ADDENDUM NO. 1

Reference: Demolish City Pool & Create Intramural Ball Fields
Southern Utah University – Cedar City, Utah
Project No.07273050

**ADDENDUM NO. 1
TO
CONTRACT DOCUMENTS
FOR
SUU INTRAMURAL SOCCER FIELDS**

| DRAWING NO. C-2 | PROJECT NUMBER 145-10-01 |

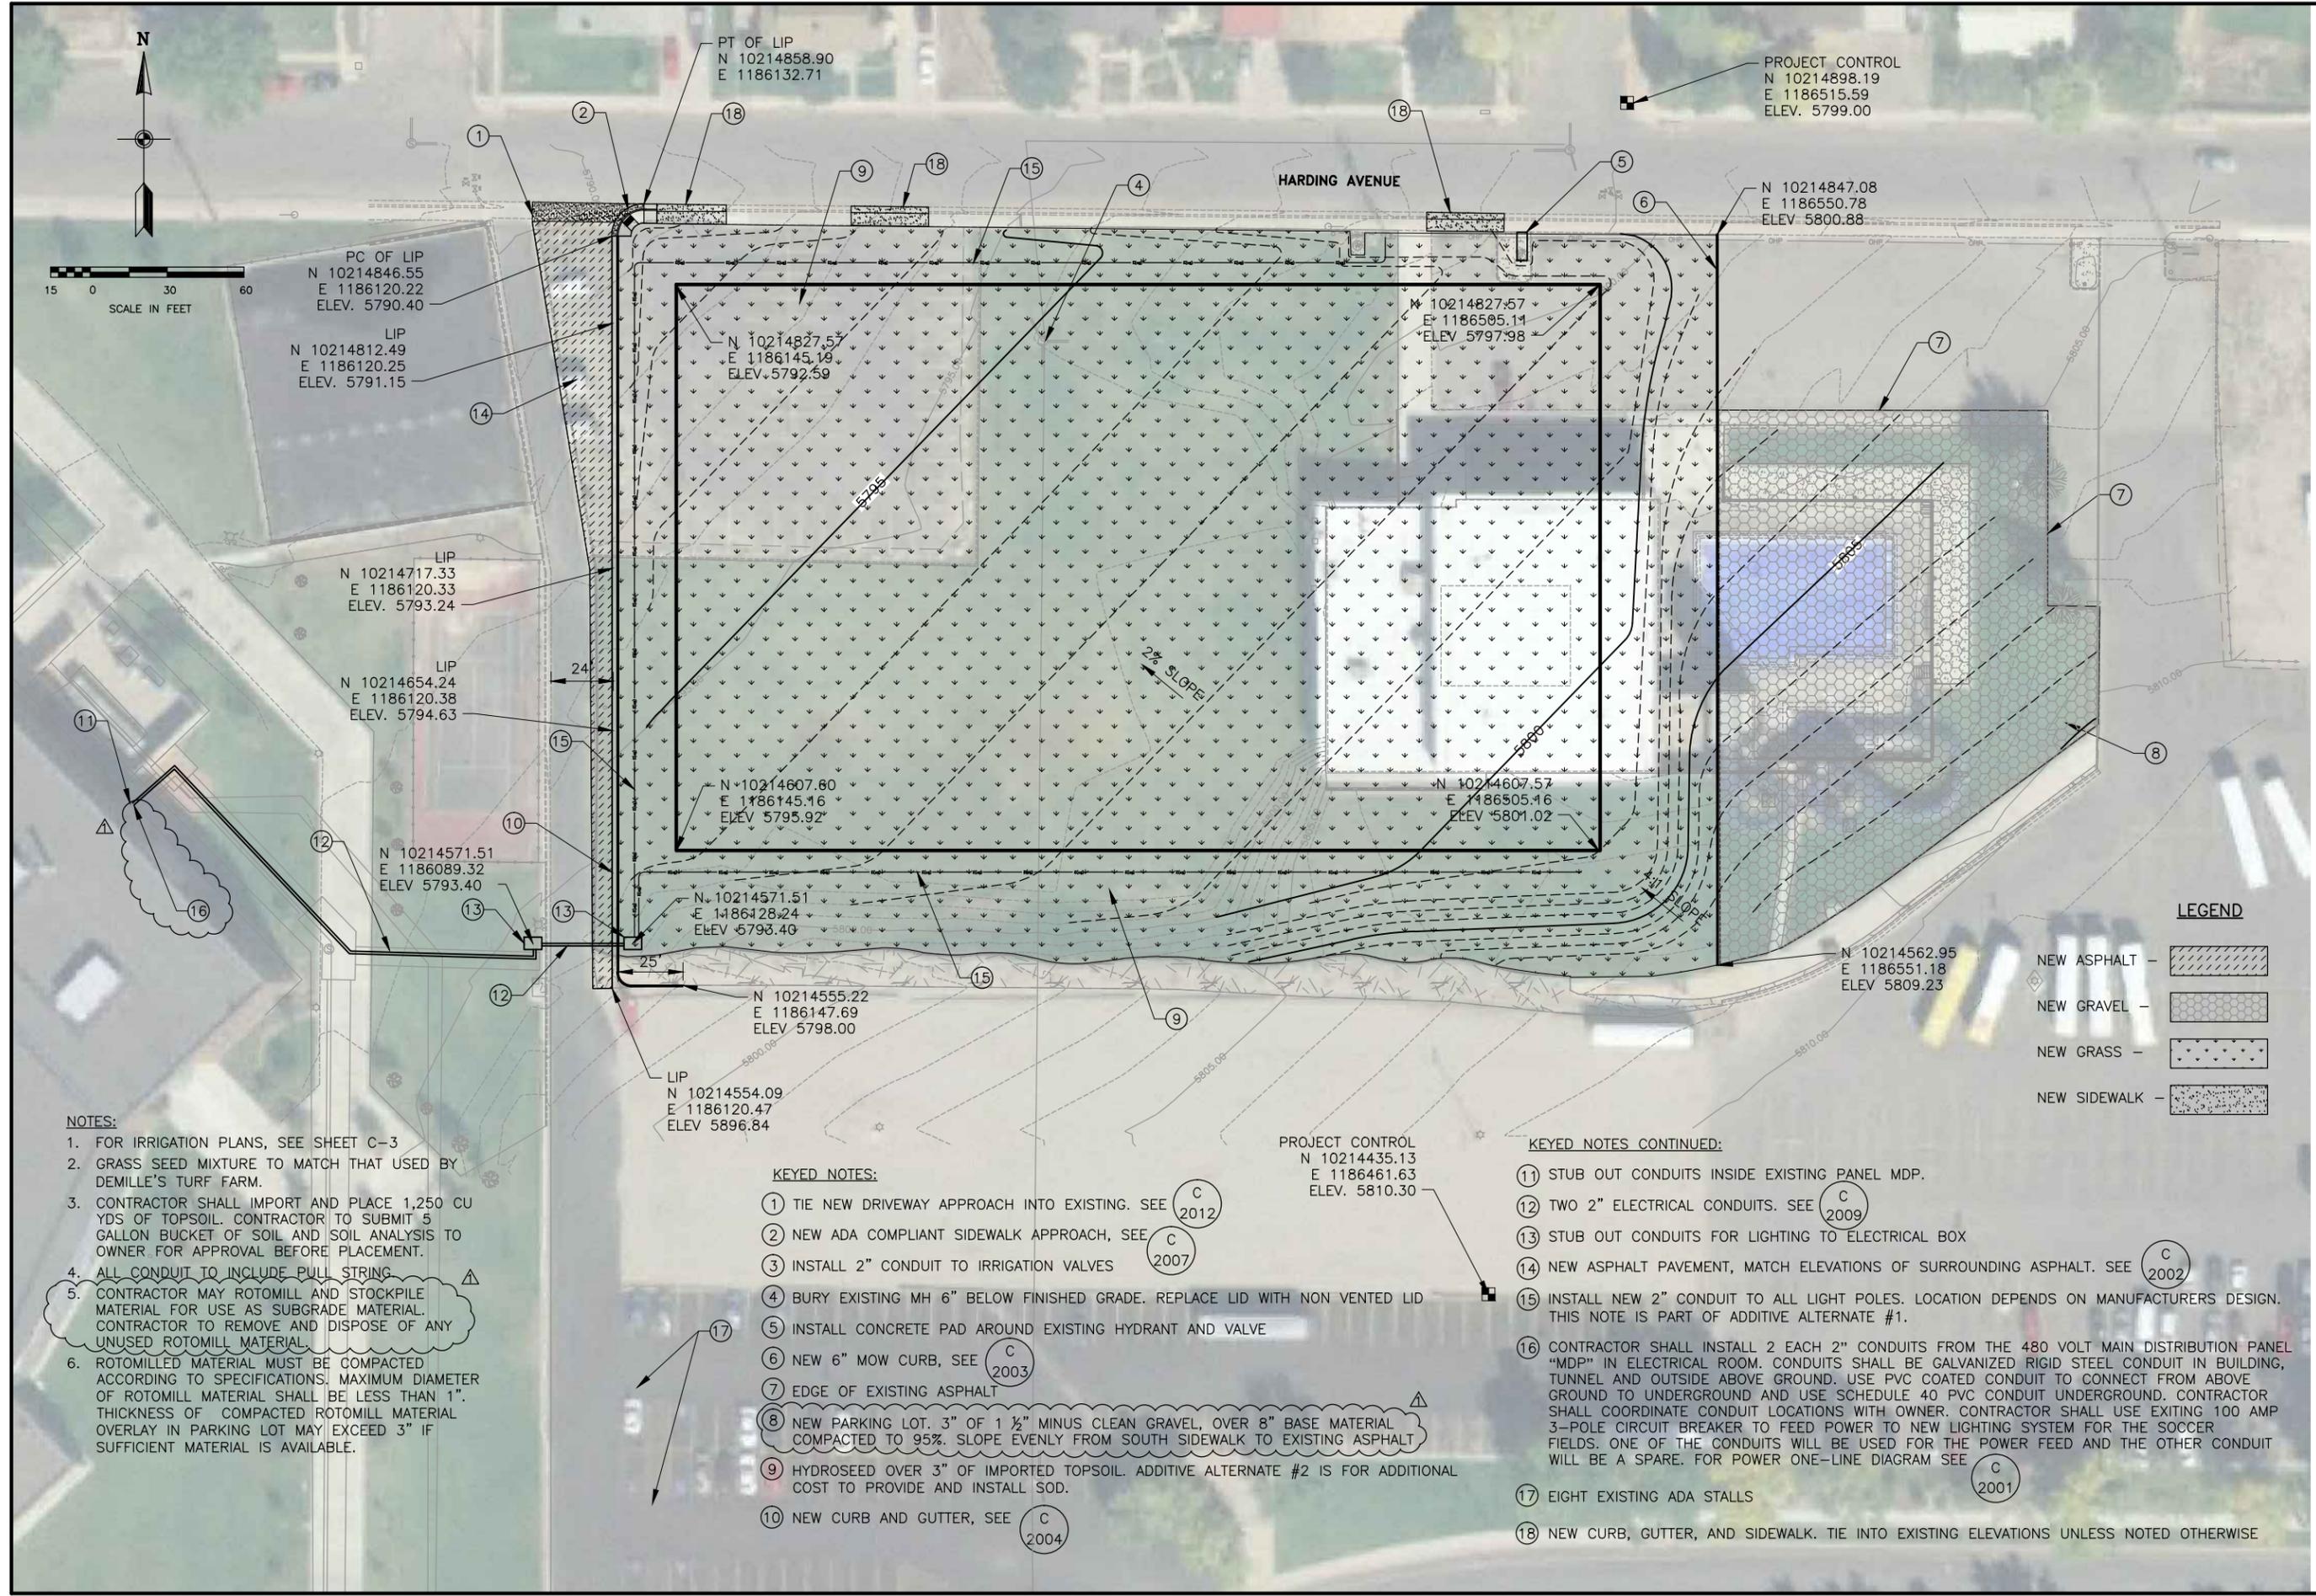
1.4.1 Drawing No. C-01, C-02, & C-03 Replace Drawings C-01 through C-03 with the attached Drawings.
